**FACILITY INSPECTION REPORT**

**FACILITY:** Mission Gorge Apartments  
**WDID/FILE NO.:** 937C369143

**INSPECTION DATE/TIME:** 12/12/2014; 9:00 am

Photo 14

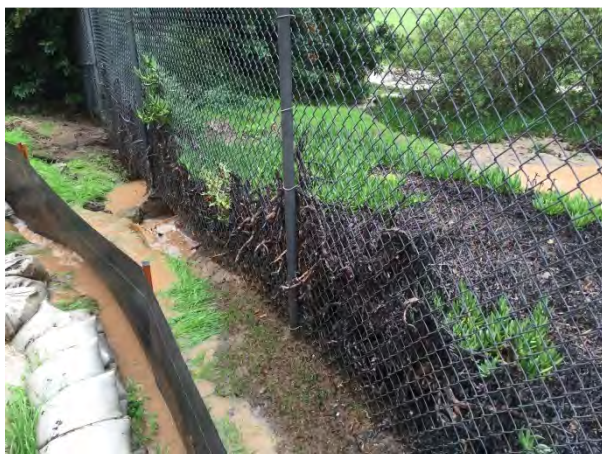
4. Lack of effective perimeter sediment controls observed which resulted in unauthorized sediment discharges from the site (See Photos 14 and 15). All construction sites are required to establish and maintain effective perimeter controls and stabilize all construction entrances and exits to sufficiently control erosion and sediment discharges from the site.

**Photos 11 through 15** show pathway to unauthorized discharges of sediment and sediment-laden storm water runoff from the site to the San Diego River. Photo 11 shows area where runoff in Photos 5 through 8 collect. Photo 12 shows where runoff from Photo 11 flow down slope. Photo 13 shows where flow from Photo 12 emerges. Photo 14 shows where flow from Photo 13 and Photos 9 and 10 converge and discharge from location in perimeter controls (i.e. gravel bags) that appears to have been moved to allow flow off site. Photo 15 shows sediment-laden storm water runoff flowing off site to the San Diego River due to inadequate implementation of erosion controls, runoff controls within the site, and perimeter sediment controls.
